PLANNING COMMISSION MEETING
Monday, May 28, 2026 – 7:00 p.m.
Farmington City Hall
23600 Liberty Street
Farmington, MI 48335

Subject: Vibe Credit Union (Site Plan Review)
Location: 31806 Grand River Ave (parcel ID: 23-27-403-141)
Zoning: C2 Community Commercial
Plan Date: April 24, 2026
Applicant: Hunter Karam

Description Site Plan Review – 33224 Grand River Avenue, Farmington Village Place

CHANGE OF USE EXISTING SITE PLAN

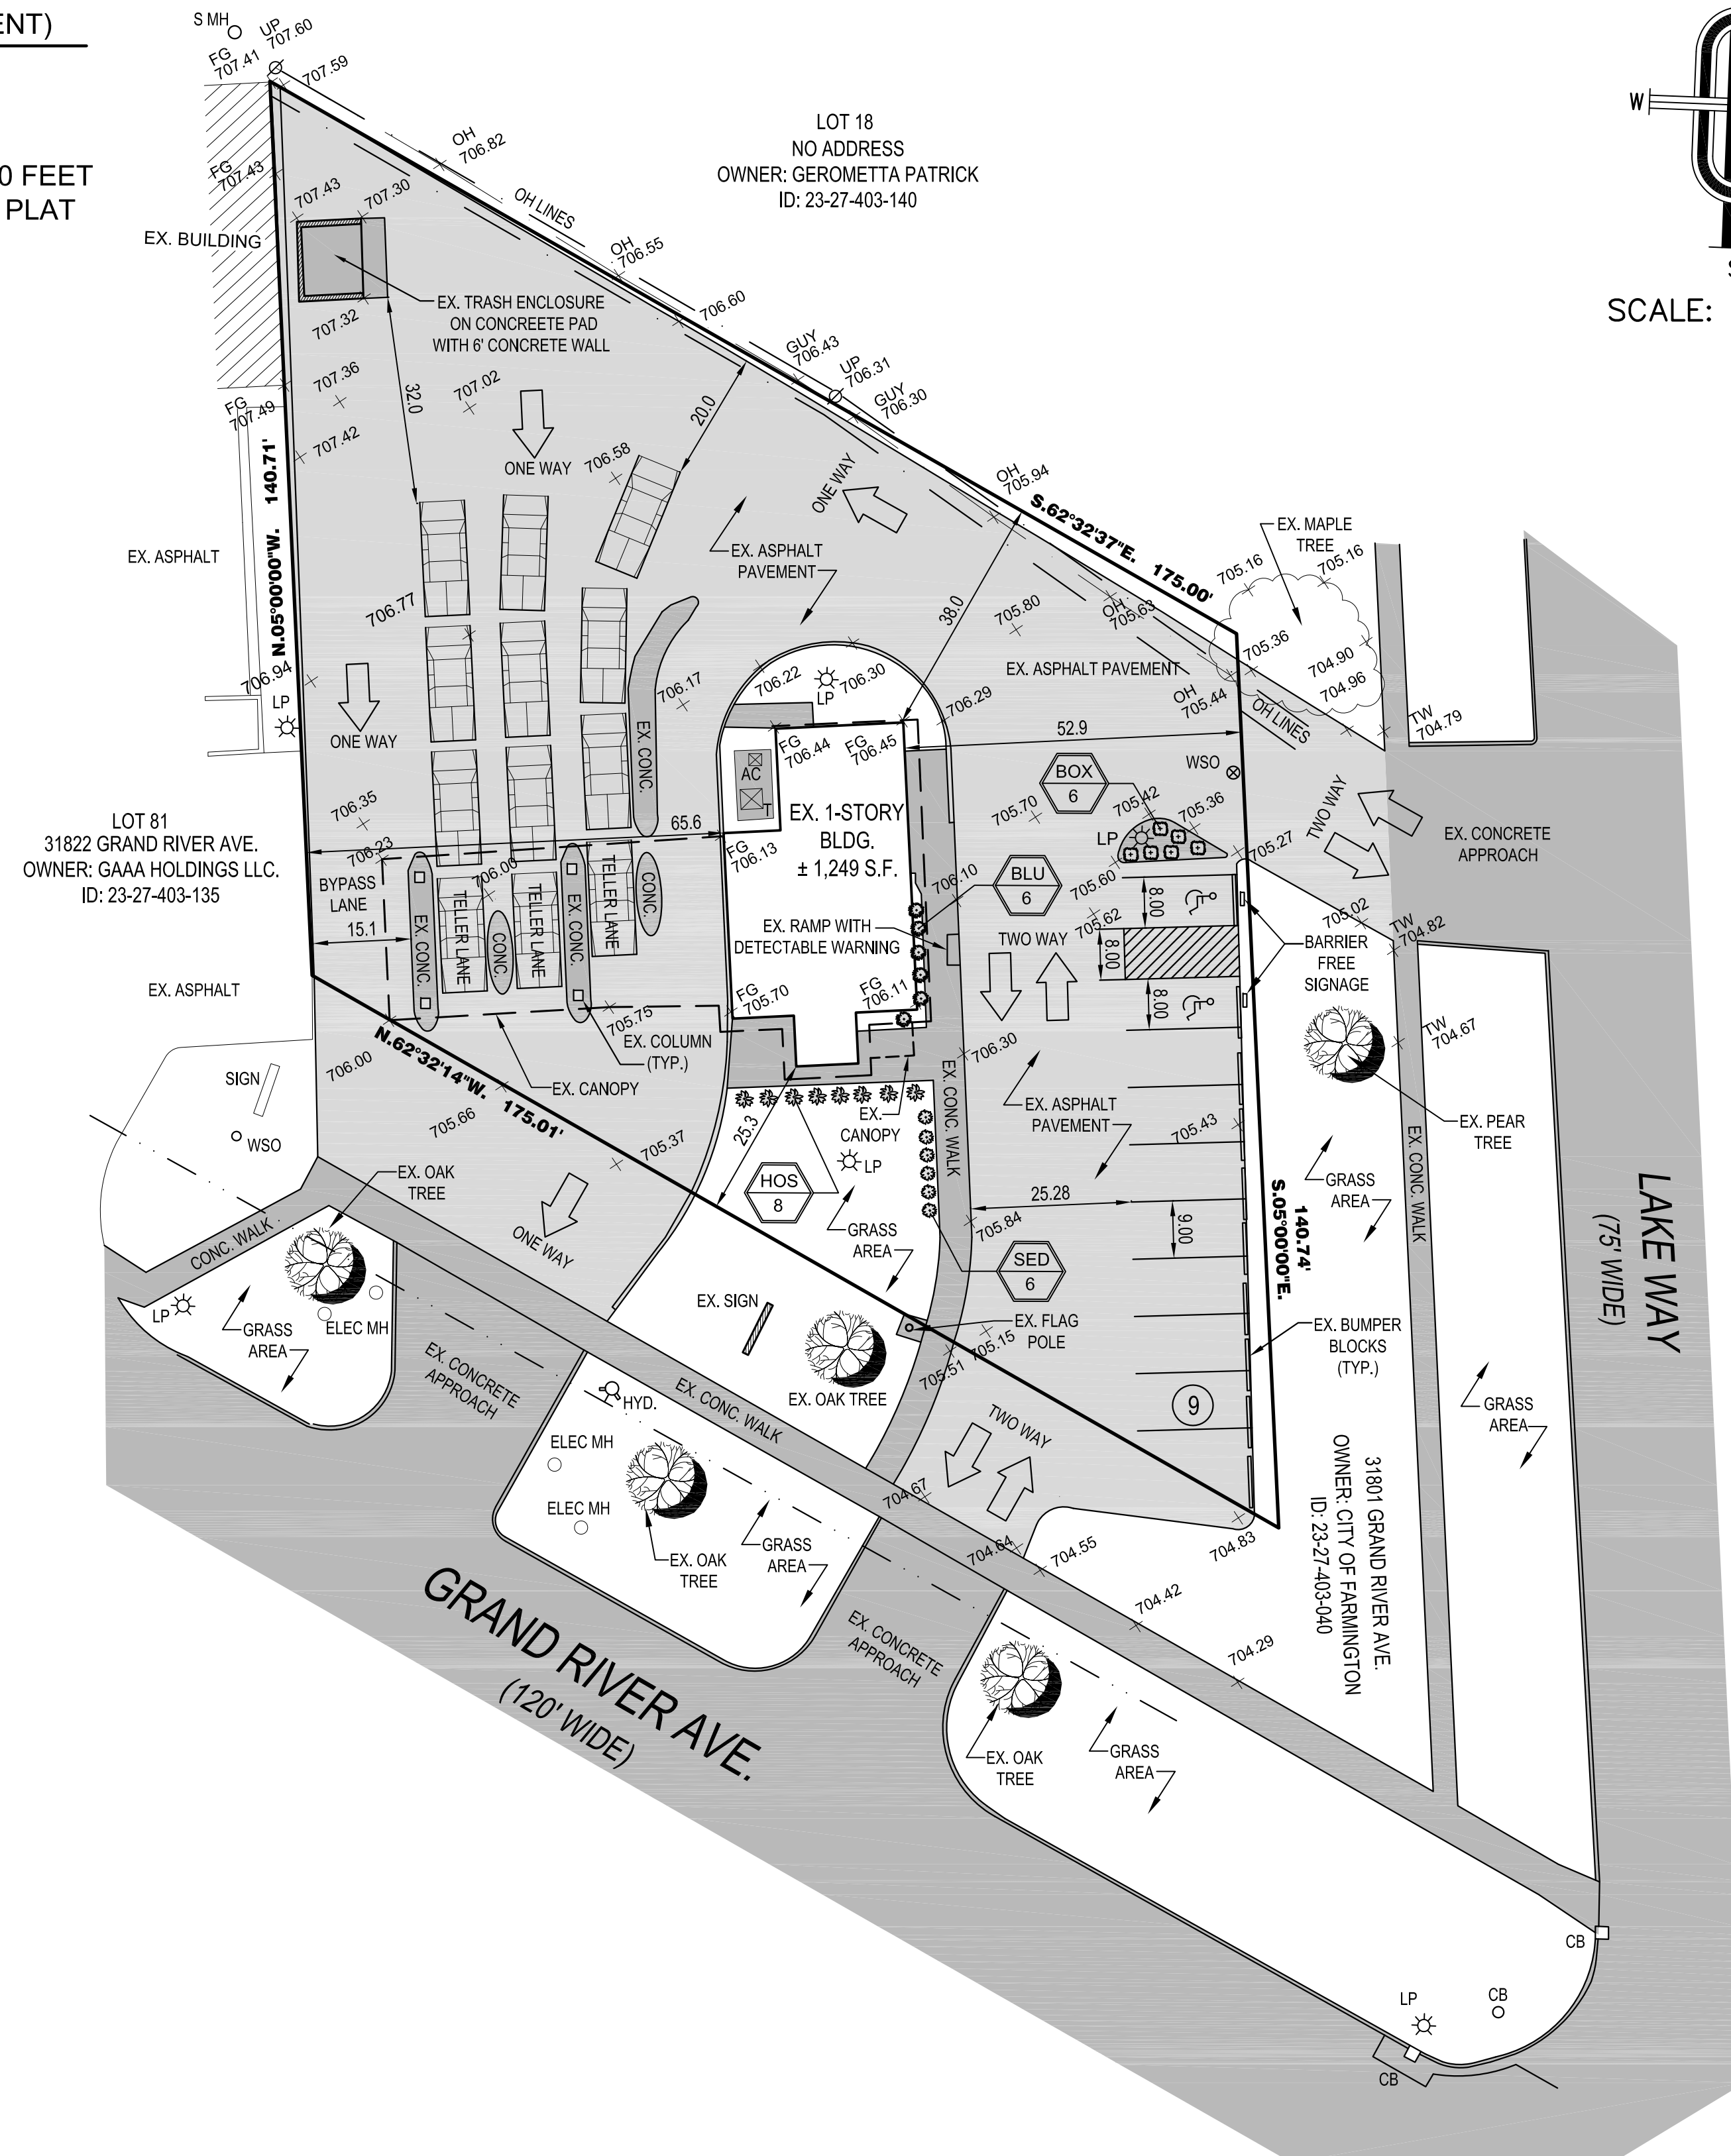
the front and east side of the building.	
Frontage	10' wide greenbelt with 1 canopy tree and 6 shrubs per 30 linear feet of road frontage or a hedgerow. The applicant has approx. 175' of frontage which would require 6 trees and 35 shrubs.	The site plan shows 3 existing canopy trees along the frontage. No shrubs are proposed. We note that there does not appear to be room for 3 additional trees but there may be room for 1 additional tree.	Does not meet standard. <u>The applicant should revise the landscape plan to provide the required greenbelt plantings.</u>
Buffer	N/A	N/A	Not applicable to this site.
Walls	N/A	N/A	Not applicable to this site.
Parking Lot	At least one (1) canopy tree and one hundred (100) square feet of landscape area shall be provided per eight (8) parking spaces. One canopy tree required.	The applicant proposes 6 boxwood shrubs in the landscape area on the east side of the building.	Does not meet standard. <u>The applicant should revise the landscape plan to provide the required canopy tree in the parking lot.</u>

Waste receptacle, mechanical equipment and utility screening	The mechanical equipment on the west side of the building should be screened.	No screening was proposed for the ground-mounted mechanical equipment. Waste receptacle is screened. No utilities are shown on site plan.	Does not meet standard.

6. Revise the landscape plan to show screening of the ground-mounted equipment on the west side of the building from public view with a solid wall, fence, plantings, berms and/or other decorative features at a height sufficient to screen the equipment.

7. Revise the landscape plan to provide the required greenbelt plantings.
8. Revise the landscape plan to provide the required canopy tree in the parking lot.

9. Revise the landscape plan to provide a hedgerow or brick street wall with a height of at least three (3) feet between the parking lot and the right-of-way line. This is a requirement for parking in the front or side yard in the C2 District.

10. The applicant must indicate the type and location of irrigation system on the landscape plan.
11. Review and approval of all applicable City departments and consultants.

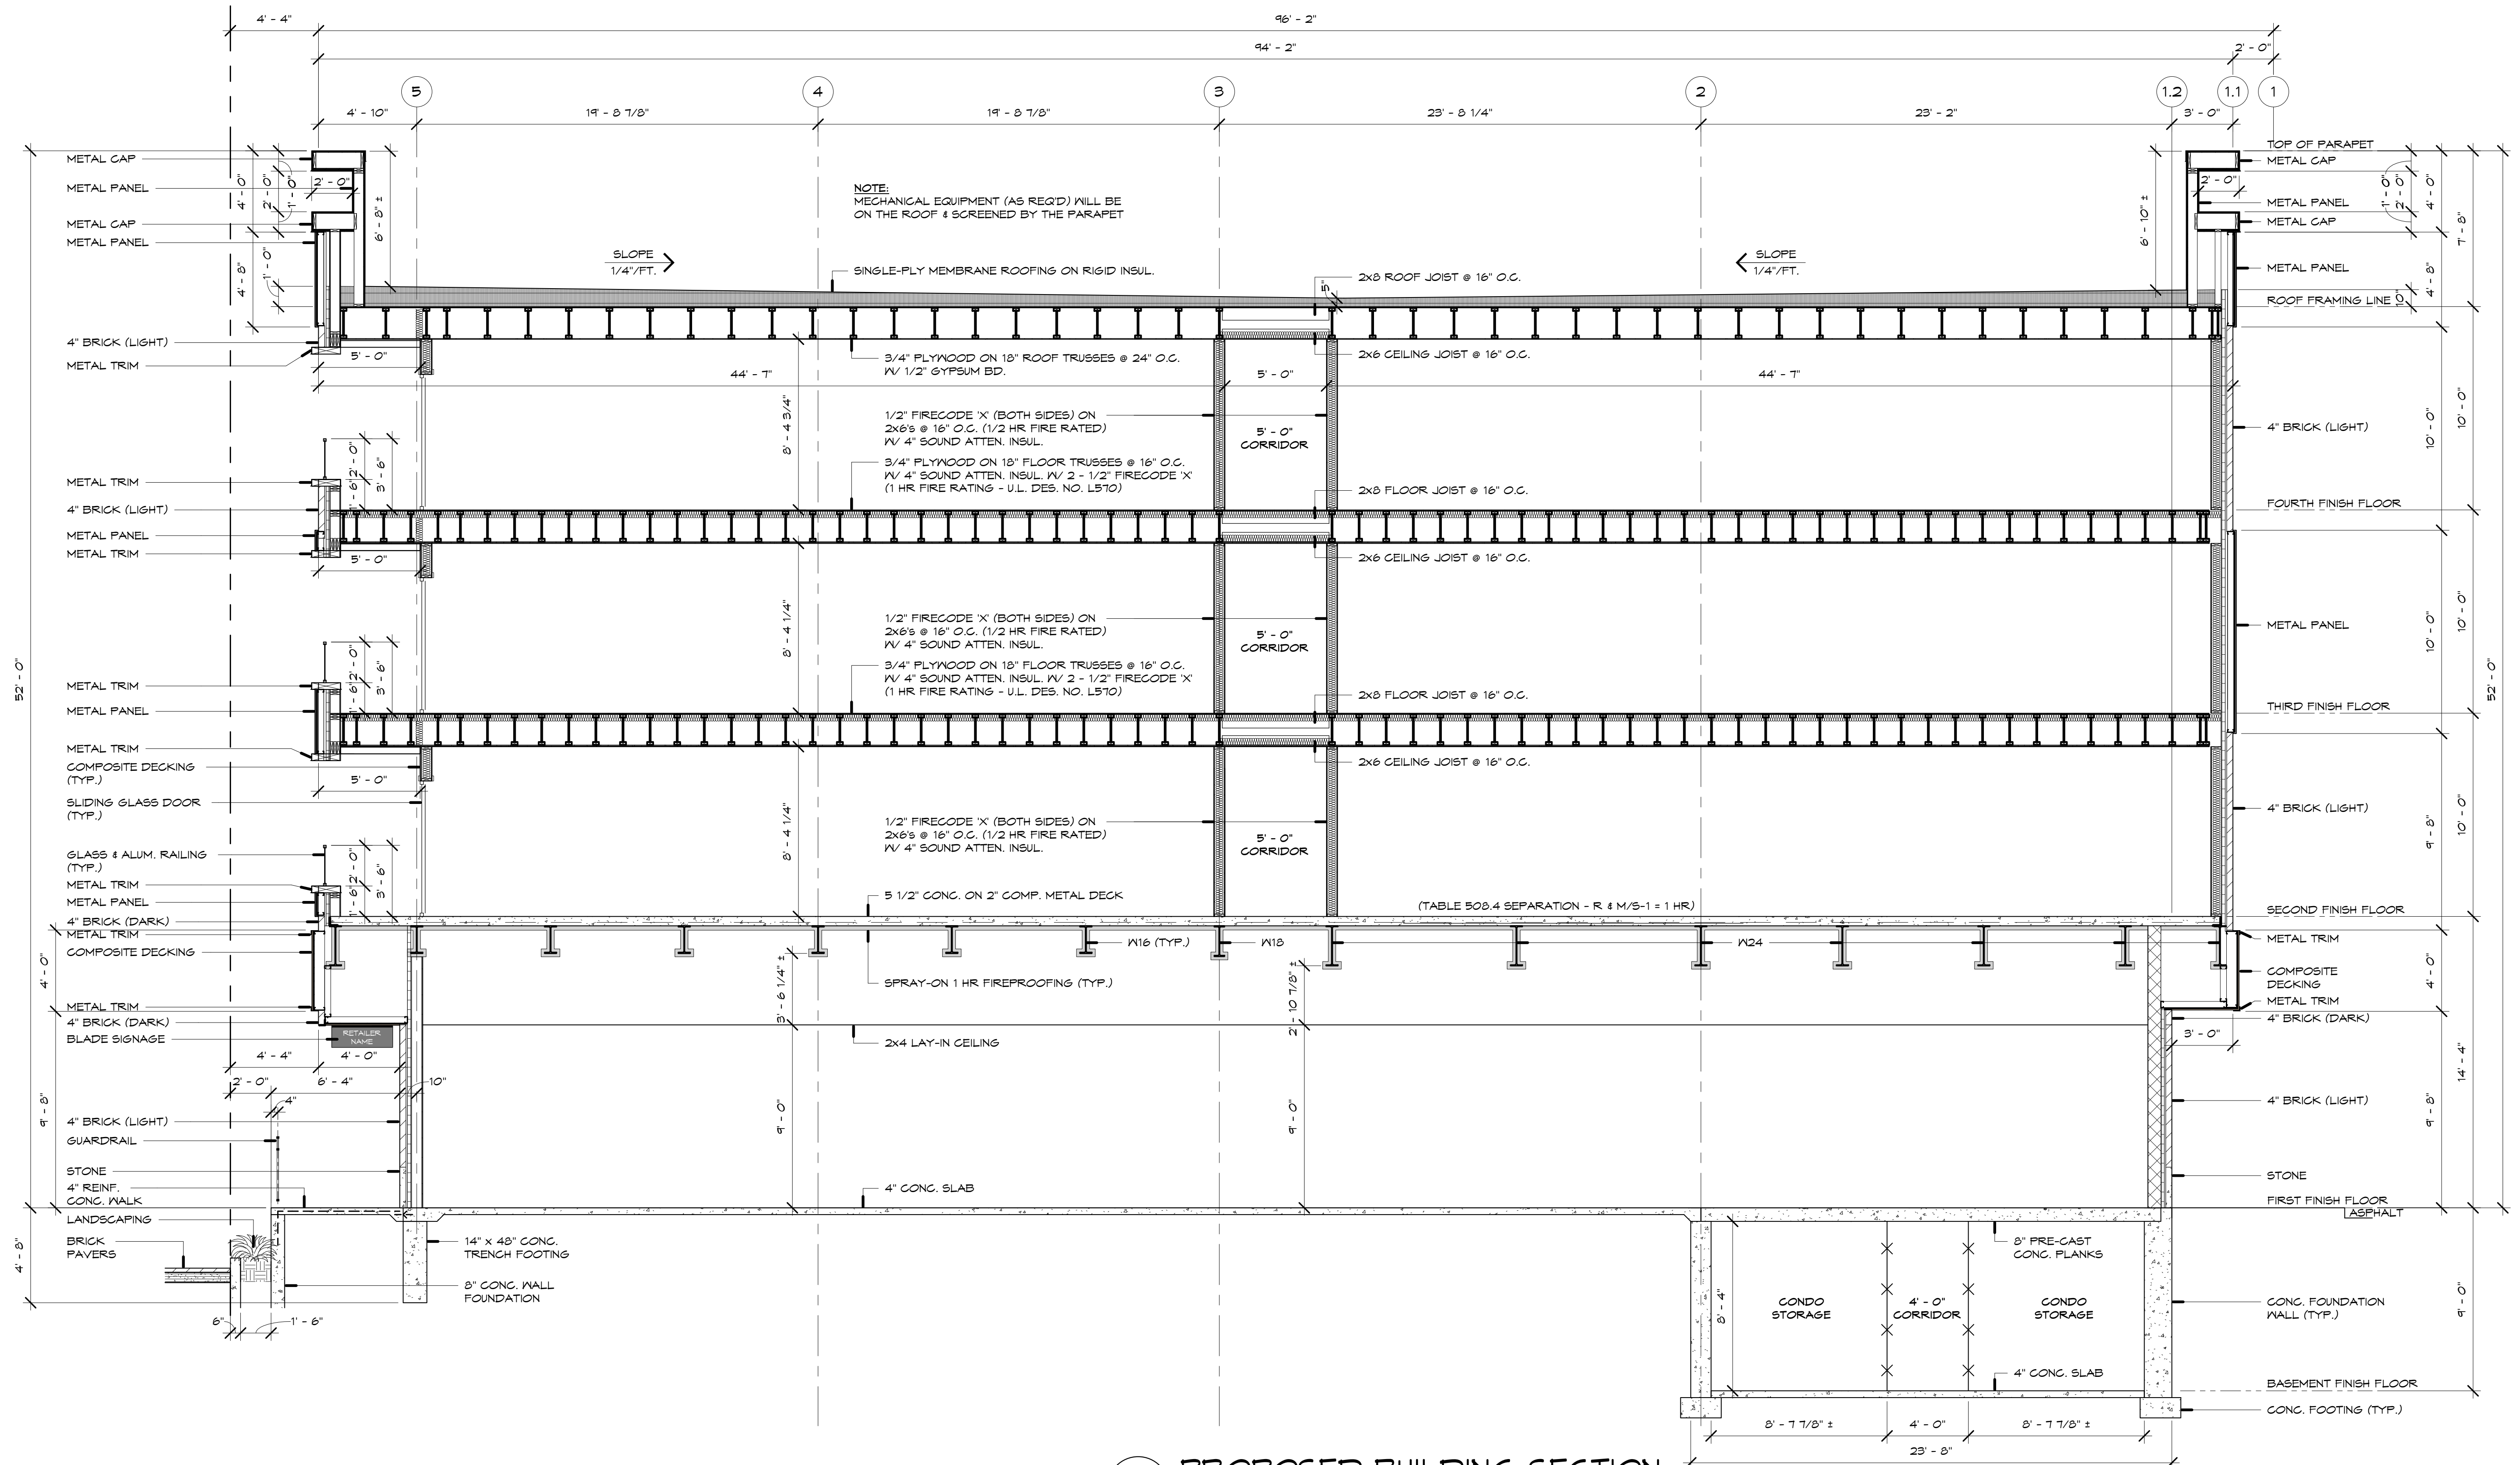
Required	Proposed	Comment
The wall shall be constructed of at least seventy-five (75) percent modular brick or stone.	Façade calculations not provided.	Potentially meets the standard. <u>Based on the elevations presented on Sheet P10, the façade may not meet this requirement. The applicant should submit façade calculations.</u>
Up to twenty-five (25) percent of the remaining wall area may include wood siding, fiber cement siding, exterior insulation finish systems (EFIS), stucco (cementitious finish), precast masonry, metal or molded polyurethane trim.	Façade calculations not provided.	Appears to meet or exceed standard. <u>The applicant should submit façade calculations.</u>
Exterior walls that may be concealed by future building development on adjacent sites may be constructed of lower-cost materials that are consistent with the building façade...	The applicant has proposed brick, metal panel, metal trim, composite material and stone – consistent with the building façade.	Meets standard.
